ATTACHMENT 1
TECHNICAL SPECIFICATION CHANGES

ATTACHMENT 2
SAFETY EVALUATION

INCREASE IN MAXIMUM INITIAL ENRICHMENT TO 4.45 W/O U-235 FOR FUEL STORAGE IN REGION 2 OF THE SPENT FUEL POOL

FIGURE 3.9-1

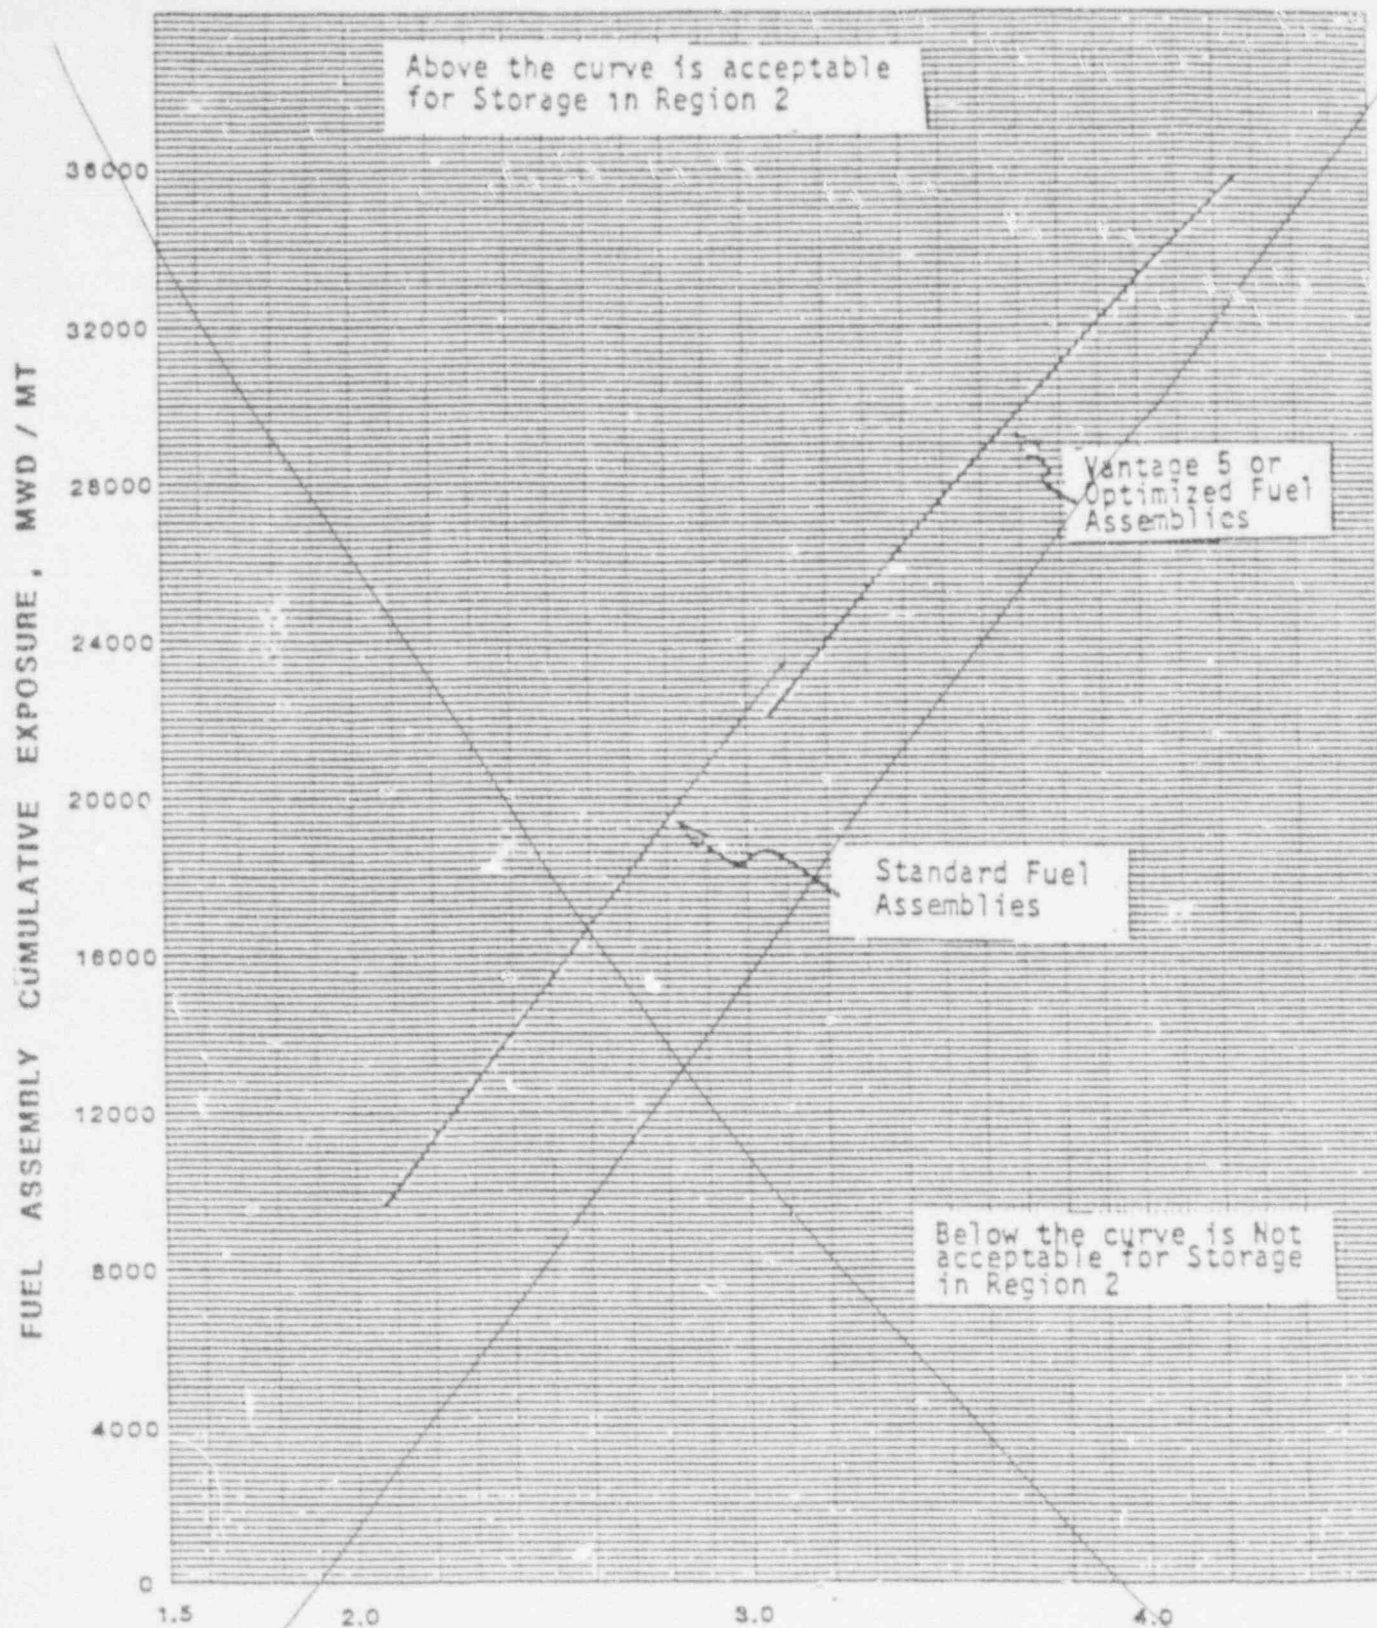
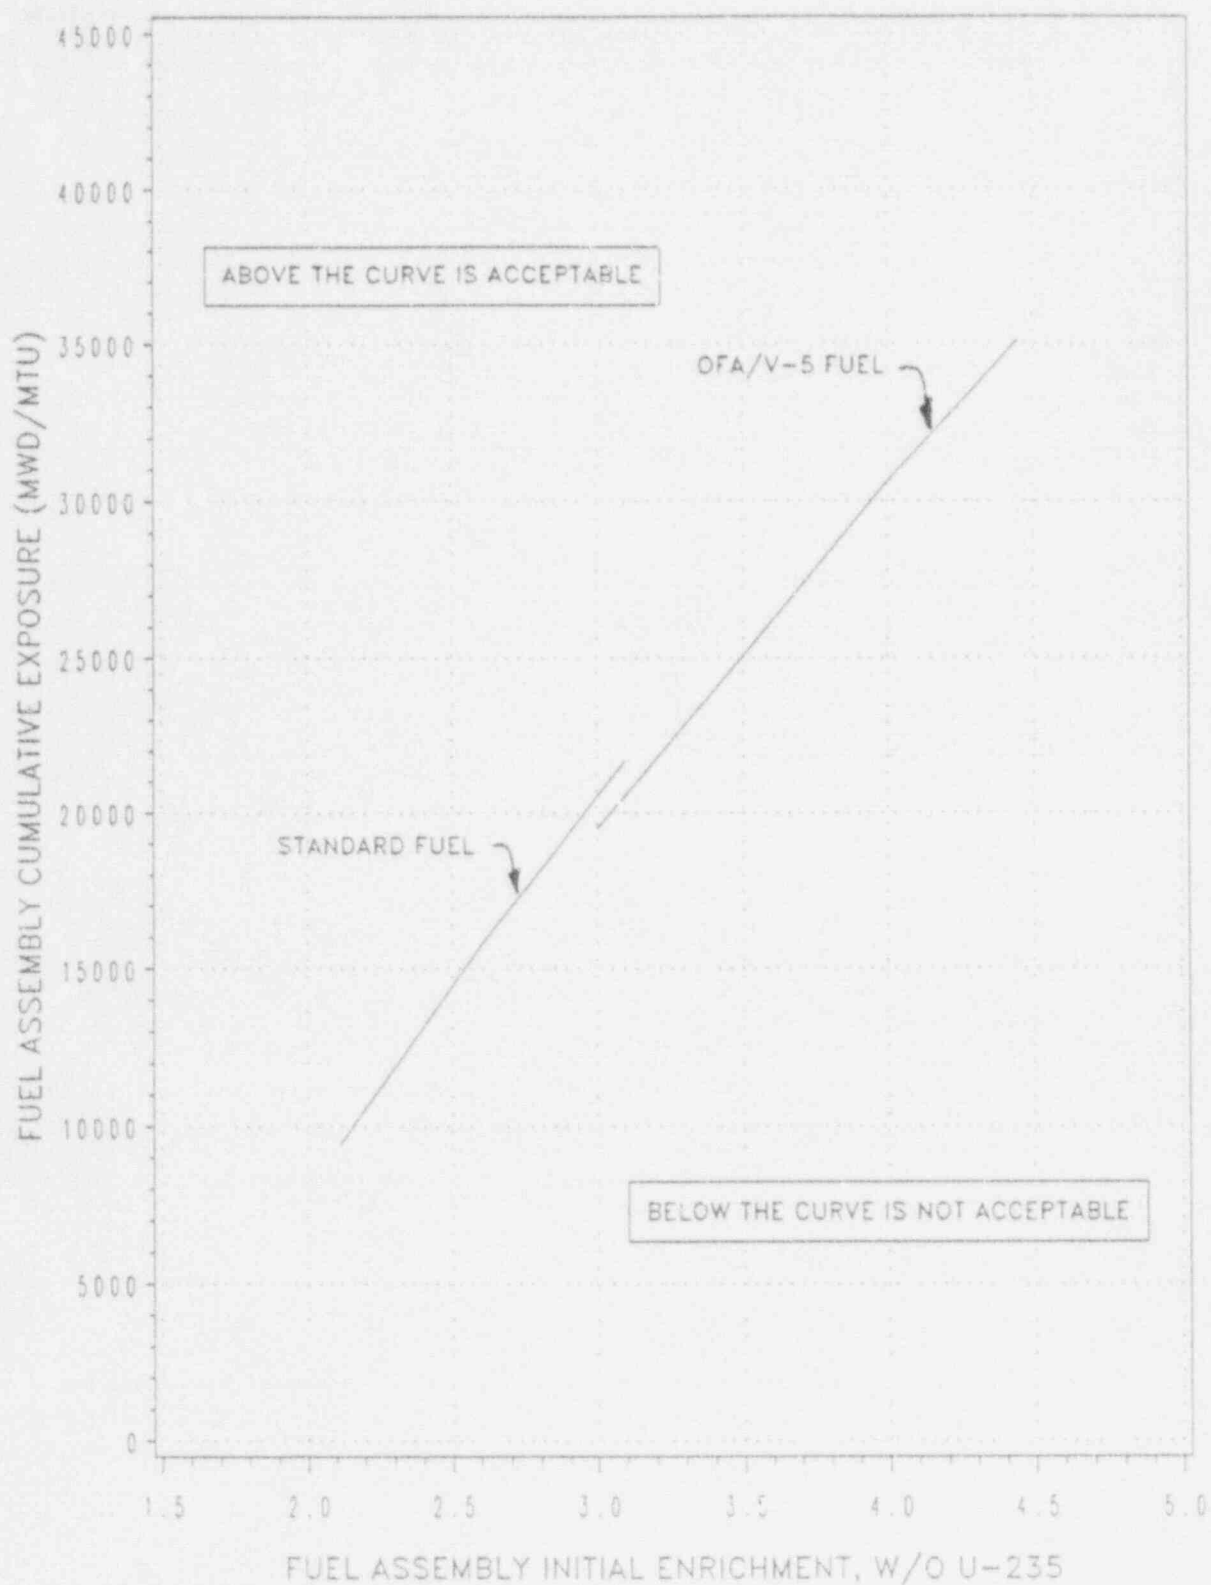
DELETE

REPLACEMENT FIGURE

This amendment request is in support of Callaway Refuel 6. During Refuel 6, fuel with a maximum initial enrichment of 4.40 w/o U-235 will be discharged. This amendment requests that Technical Specification section 3.9.12 be revised to reflect a maximum initial enrichment of 4.45 w/o U-235 for fuel storage in Region 2.

FIGURE 3.9-1
MINIMUM REQUIRED FUEL ASSEMBLY BURNUP AS A FUNCTION
OF INITIAL ENRICHMENT TO PERMIT STORAGE IN REGION 2
